**In the matter of** Variation 1 to the Proposed Waimakariri District Plan

**Council Officer's Final Right of Reply on Variation 1**

Figure 2 Hours of direct sunlight at the winter solstice

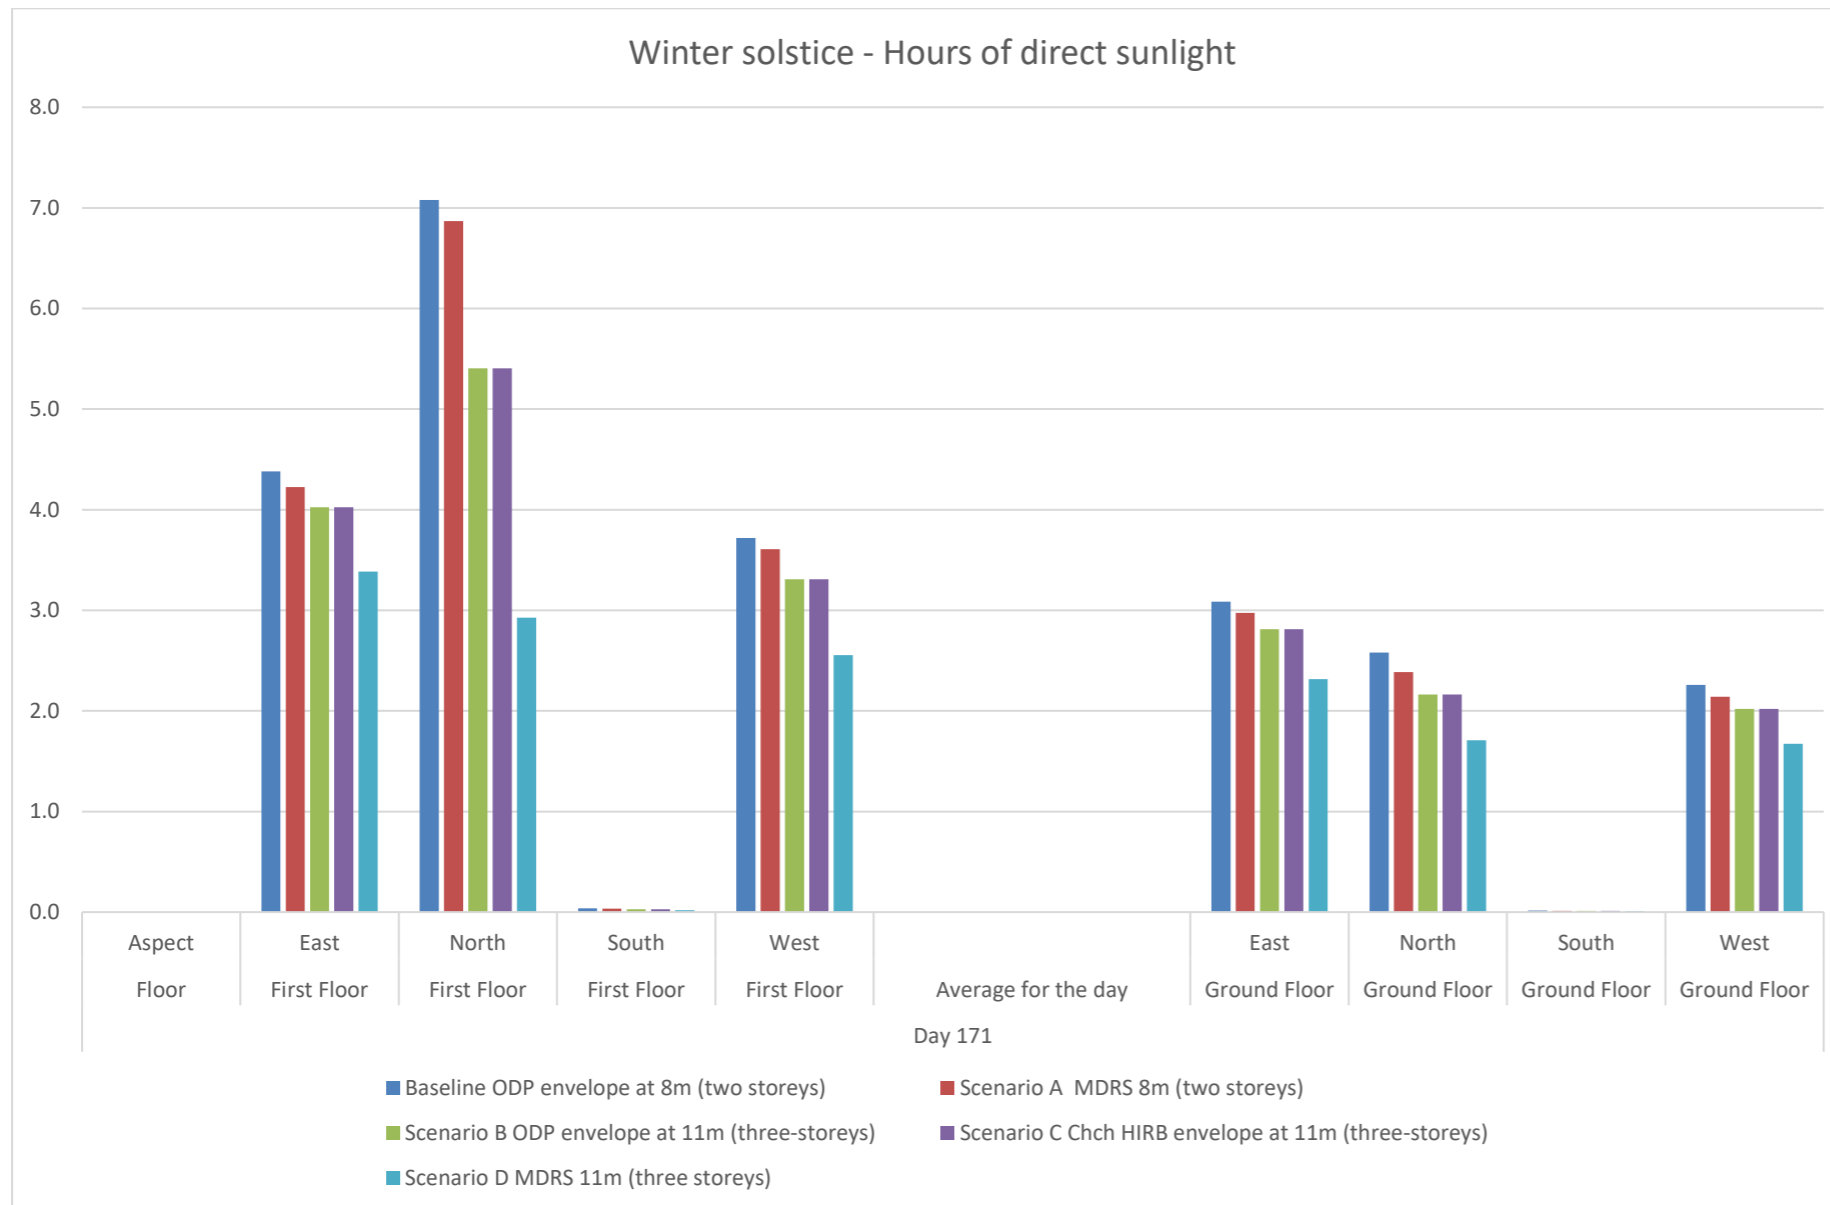
24. The Panel has asked about what is appropriate access to direct sunlight. My understanding, based on Mr McIndoe’s evidence, is that this would need to 3 hours or more for a living space. Mr Kemp, for Kainga Ora, also considered this to be a standard.

28. When a modified MDRS is modelled, the sunlight loss is less, but still between 10%-20% direct sun is lost. Only the eastern aspects of ground floor sites receive more than 3 hours of direct sunlight during winter months. Therefore, the loss of additional hours of sunlight is more substantial than in summer as the starting point is lower. Under a full MDRS, most of a ground floor of a building would struggle to receive more than 2 hours of direct sun per day. However, under a modified MDRS, aspects can receive more than two hours on northern aspects, and up to nearly three hours on eastern aspects.

**Results**

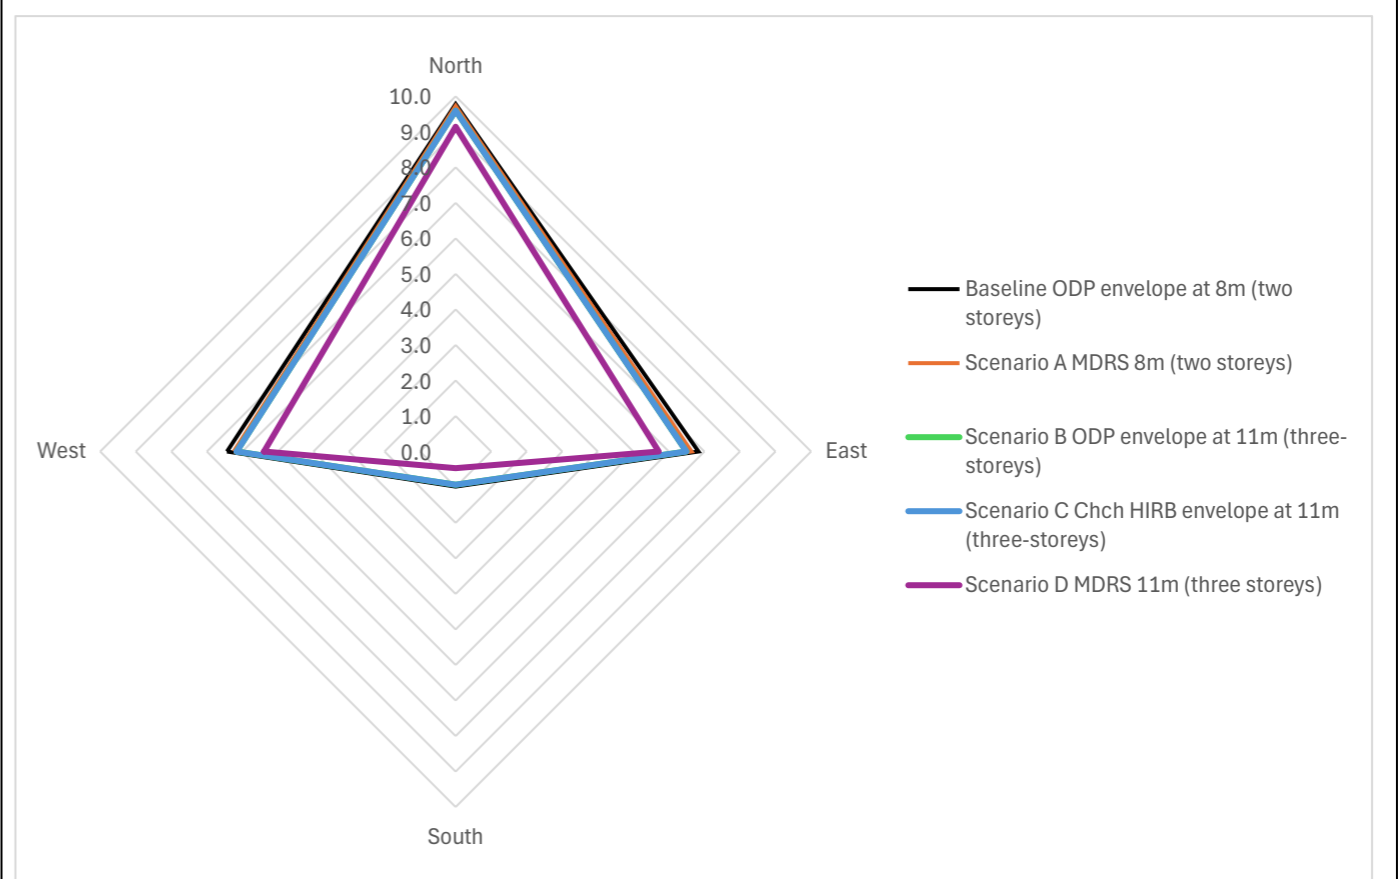
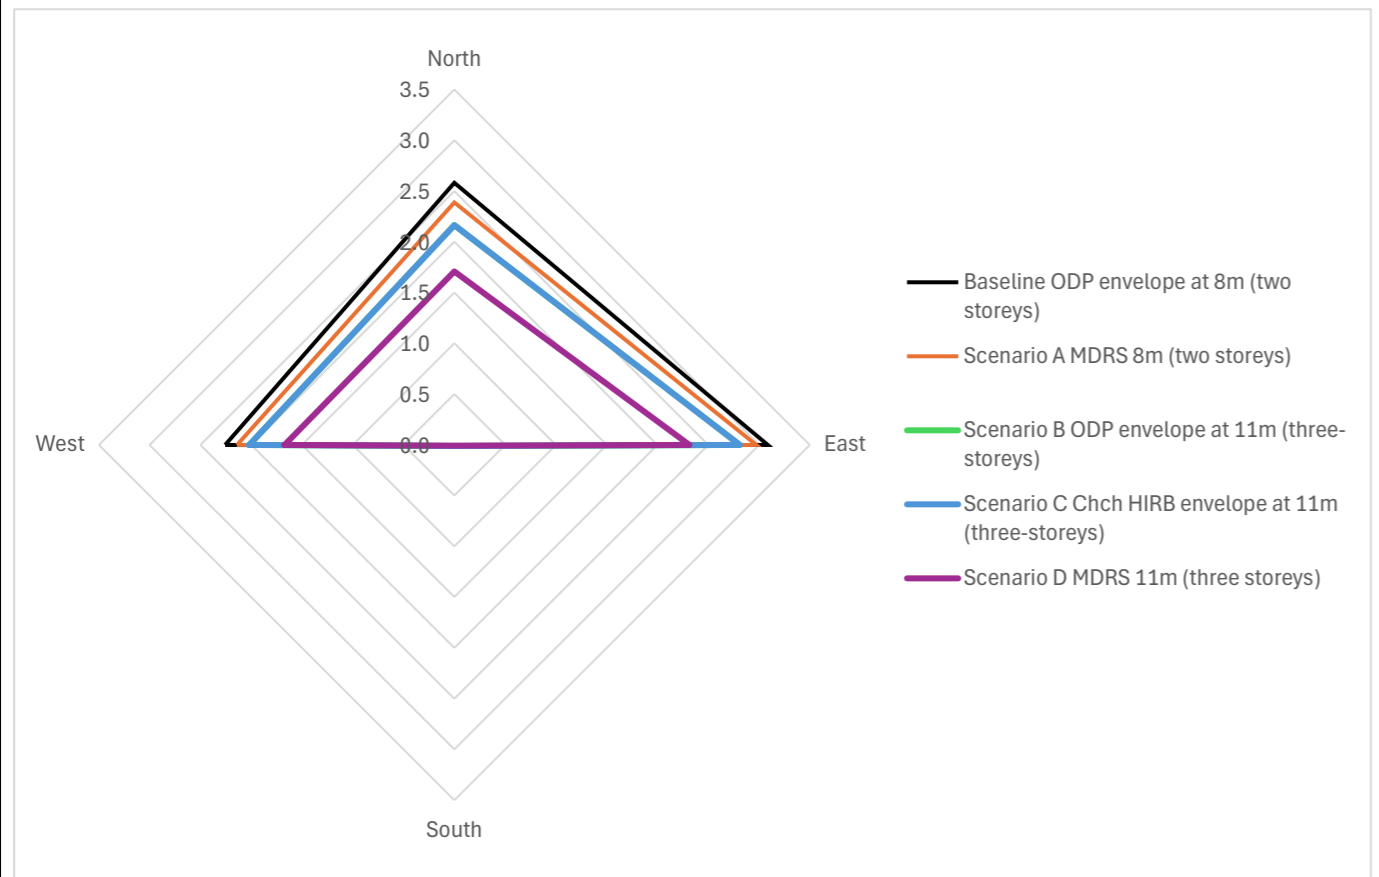
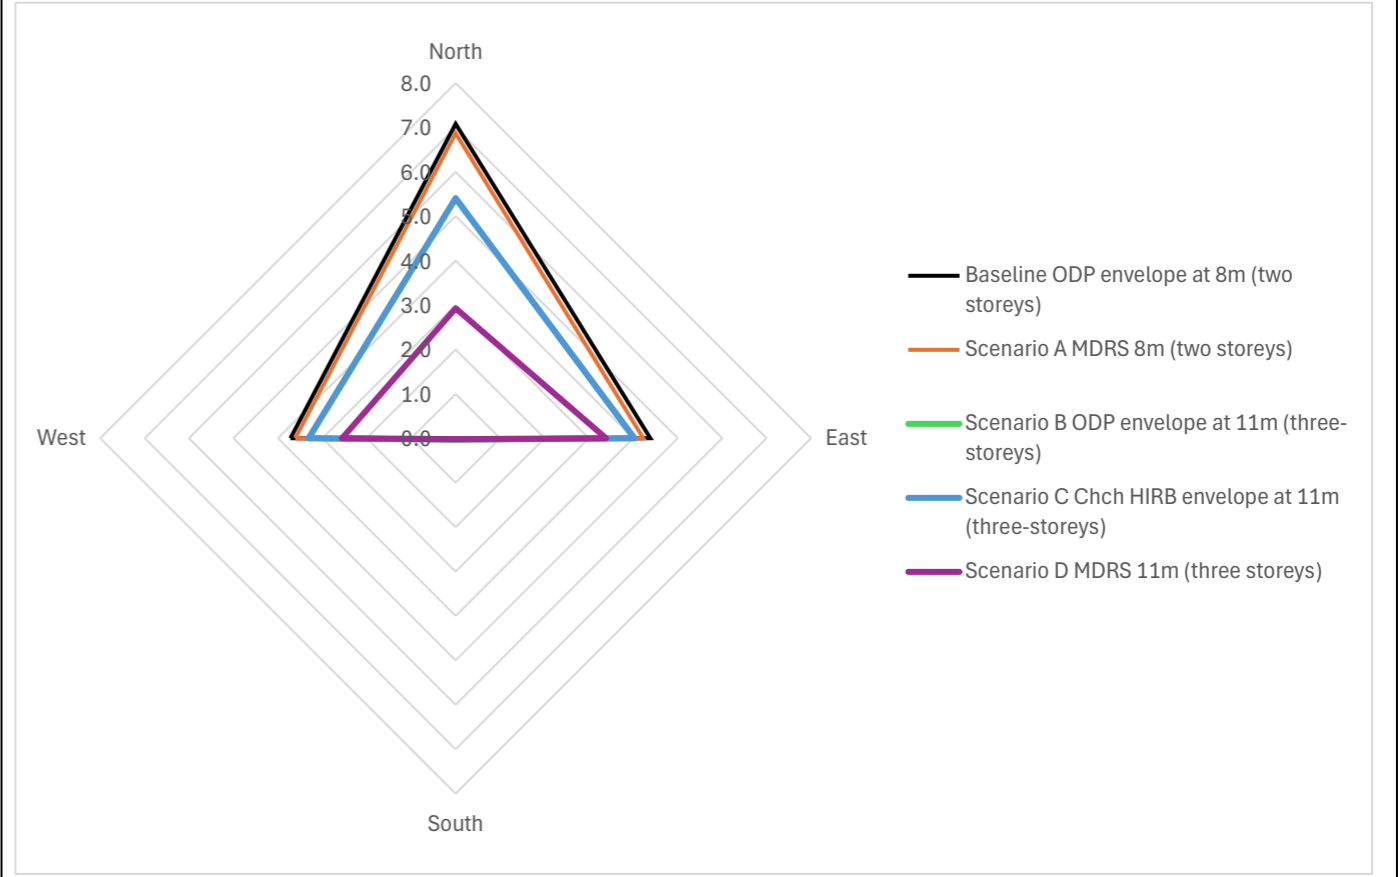
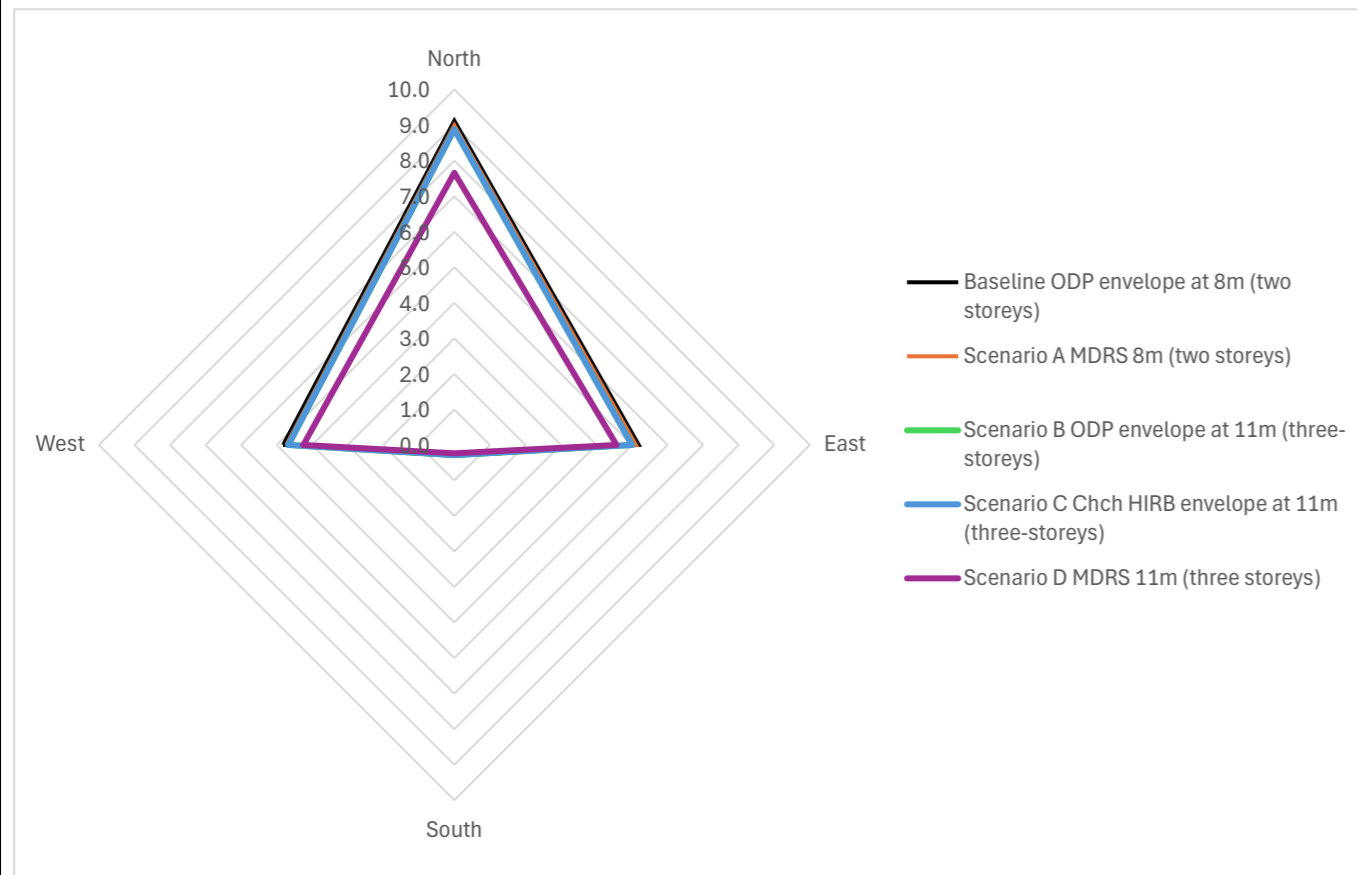
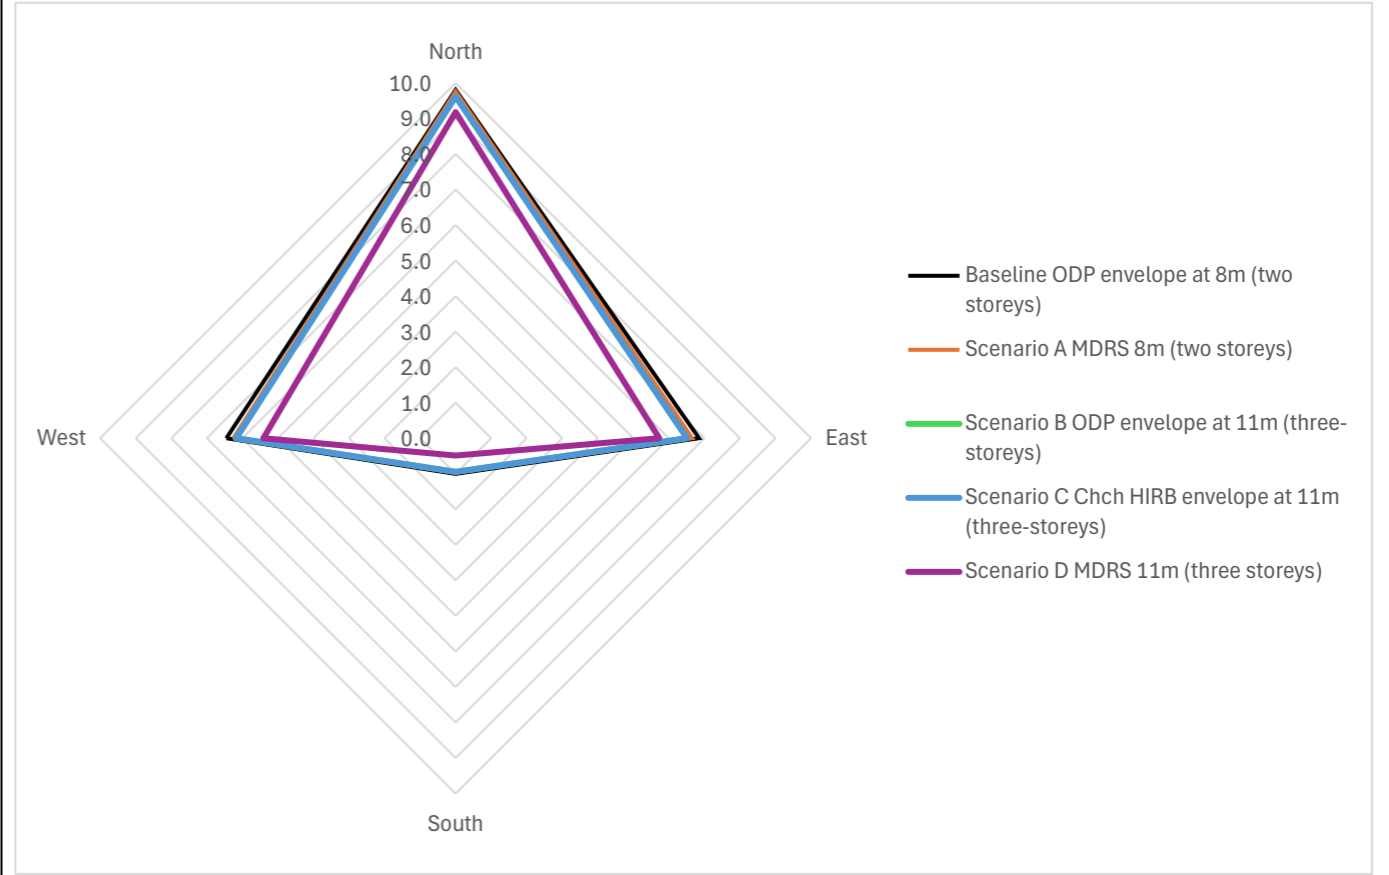
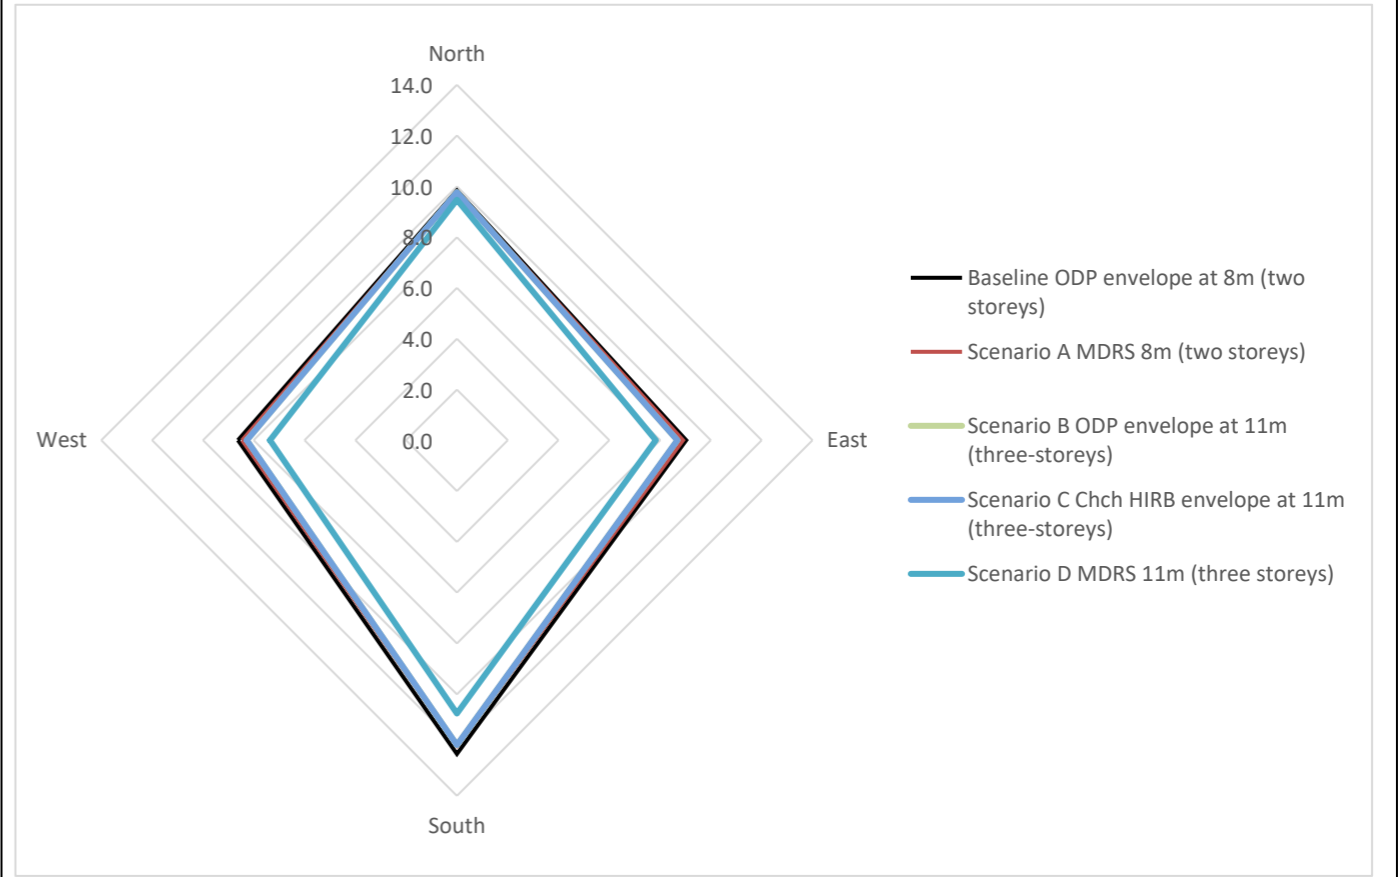
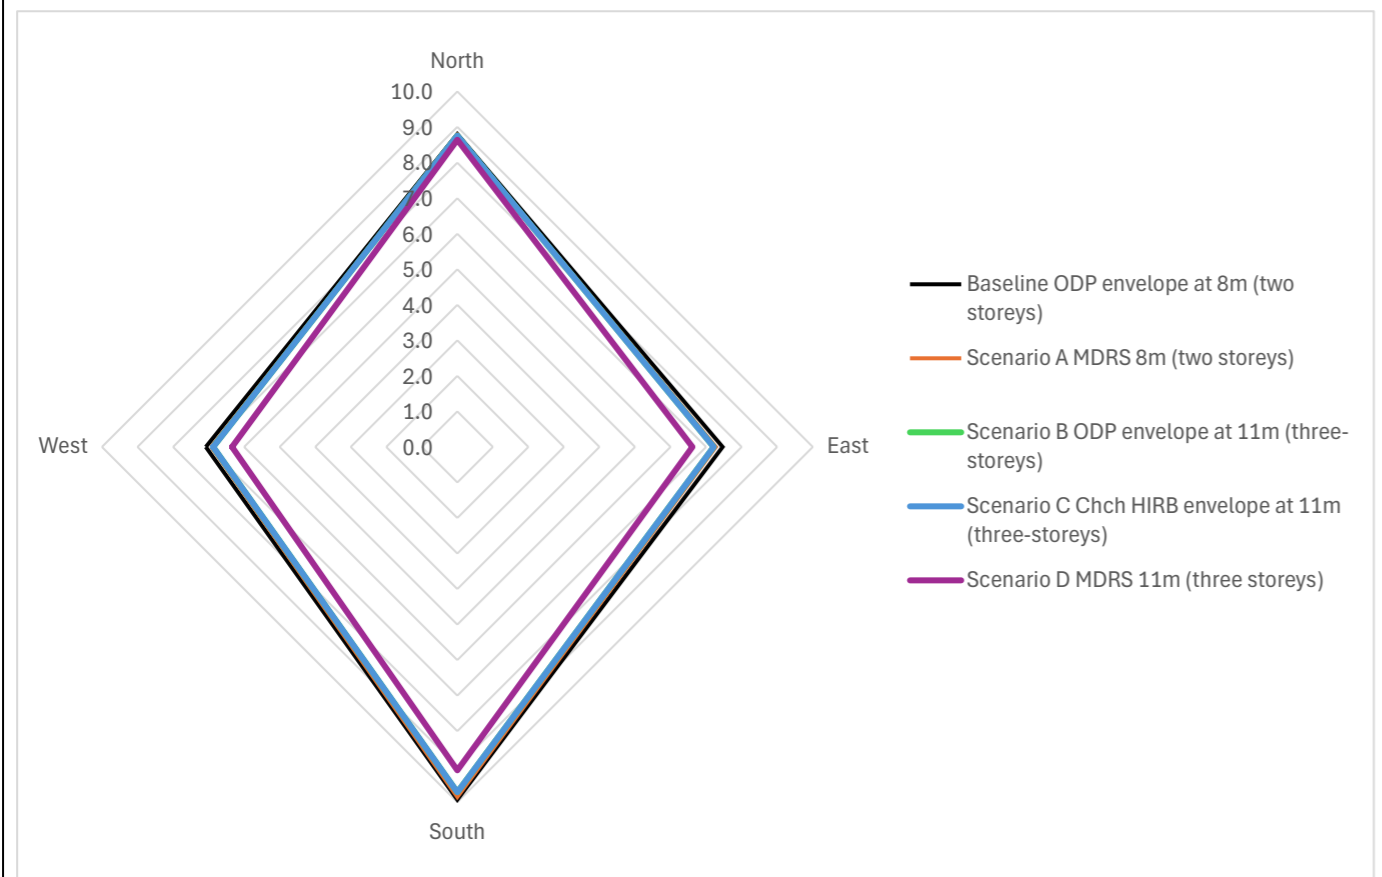
30. However, in looking at the results, a modified height in relation to boundary and recession plane angle can achieve three storeys with only a modest additional reduction in sunlight hours. This increase in shading time is of the order of 15-20 minutes or so, and may be unnoticeable at this level. Thus, in considering the results, and the requirement to limit any proposed qualifying matters to ensure that the MDRS is as enabling as possible, I do now consider that 11m, albeit with a modified recession plane, is possible. I do not consider that the full MDRS, with a 20% to 30% loss of sunlight would be appropriate, especially as on some aspects of a building it would halve the amount of direct sunlight received.

31. The choice is between Scenario B – using the operative district plan height in relation to boundary and recession planes, and Scenario C, the proposed Christchurch PC14 HIRB provisions. Within the granularity of my modelling, there is no noticeable difference between them.

Interpreting results - the radar plots below show hours of direct sunlight received on each of the four primary aspects of a building. The area within the shape is a representation of the total sunlight received. Where a coloured line cannot be seen in a plot means that it lies underneath another line, because of the similarity. In these cases, the numerical results show the difference, if any.
